No. L.S. 1930 of 1920

Municipal office

Karachi 27th March 1920

With reference to his application with plan received on 13th March 1920 for building on plot No. 2, K-5 Lyari Quarter Mr. Hoodbhoy Shalloo is informed:-

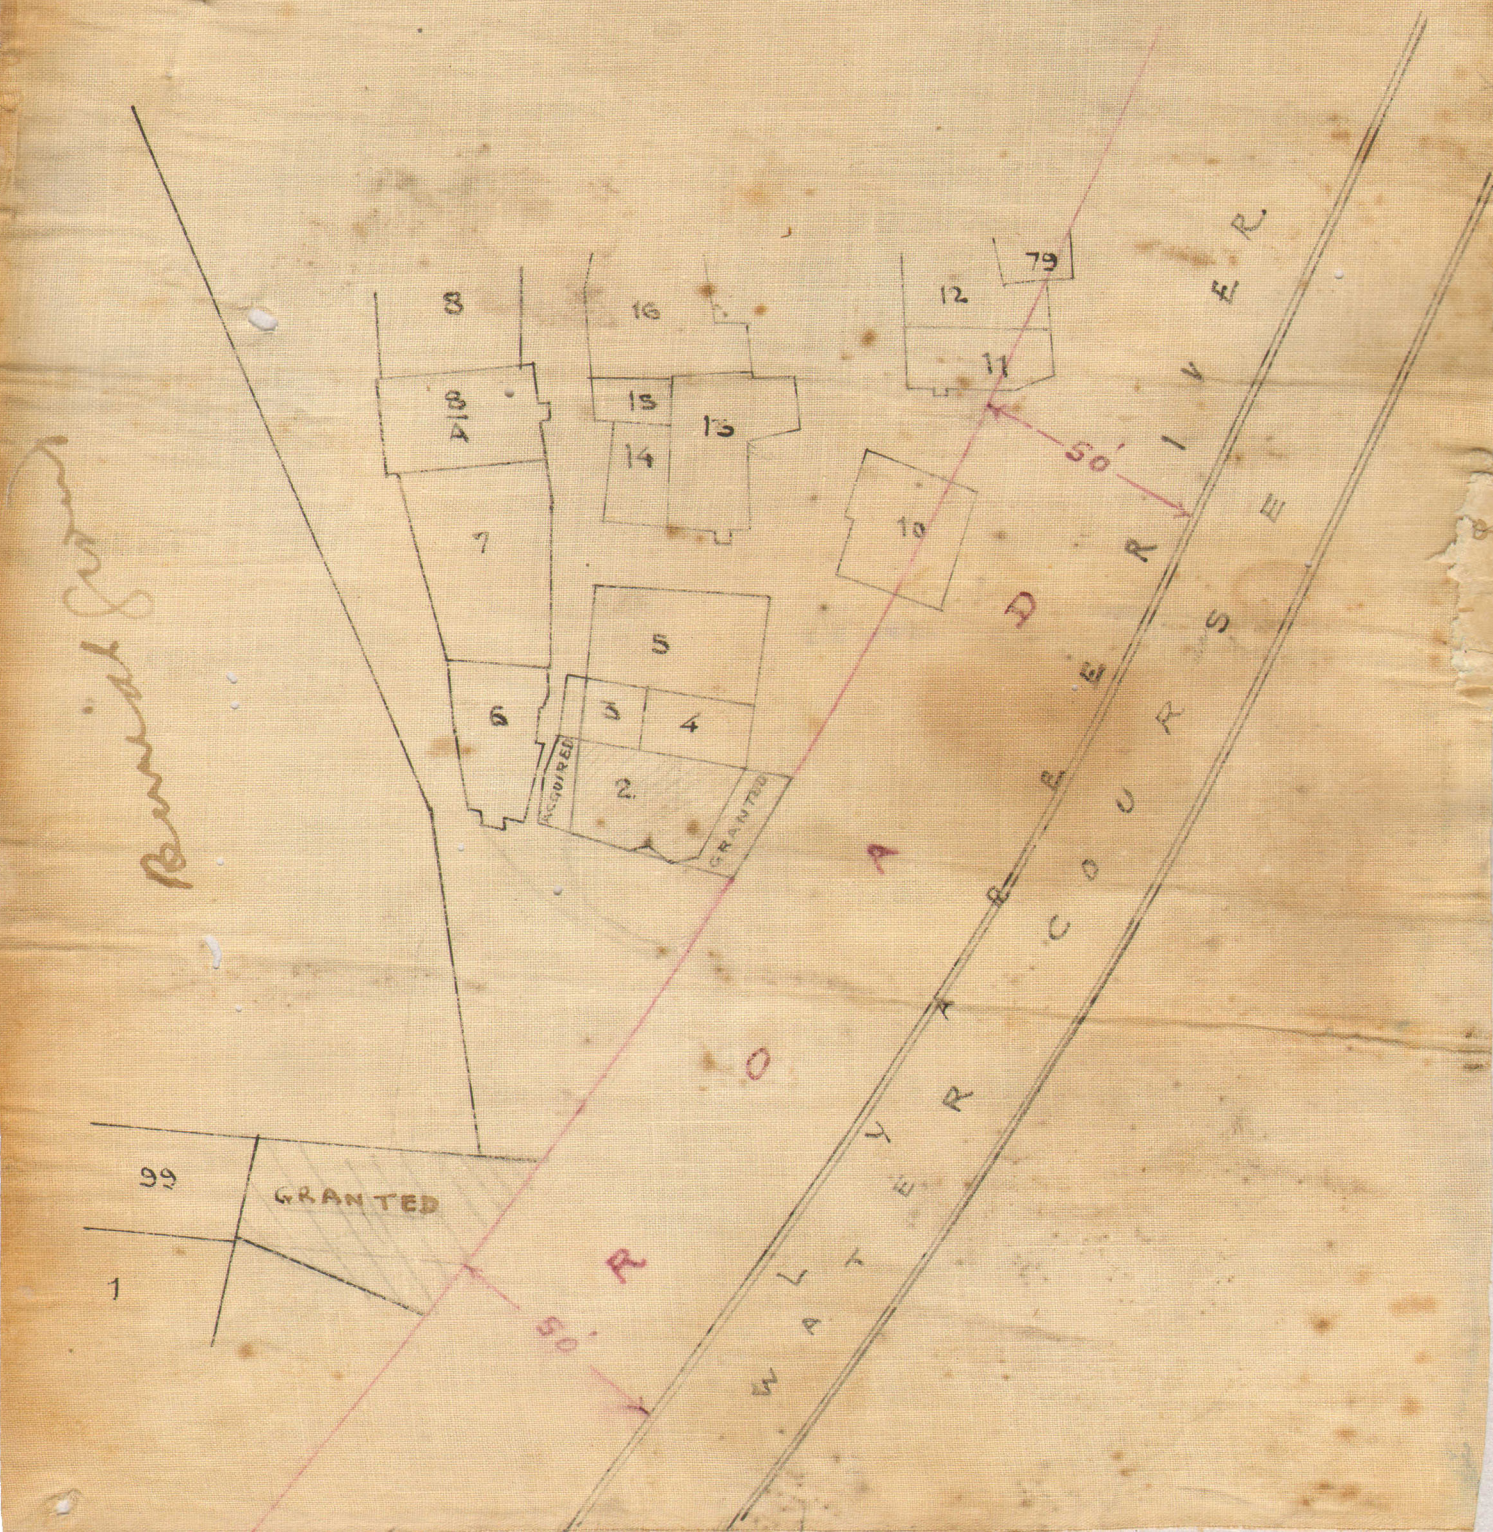
1. The plot is being overcrowded.
It is too small for a four stories
bldg.
2. The back portion of bldg is contrary
to byelaws.
3. The kutcha walls to the kitchen
and conveniences are not strong
to take the wt to put on them.

The plan is disapproved and
returned herewith
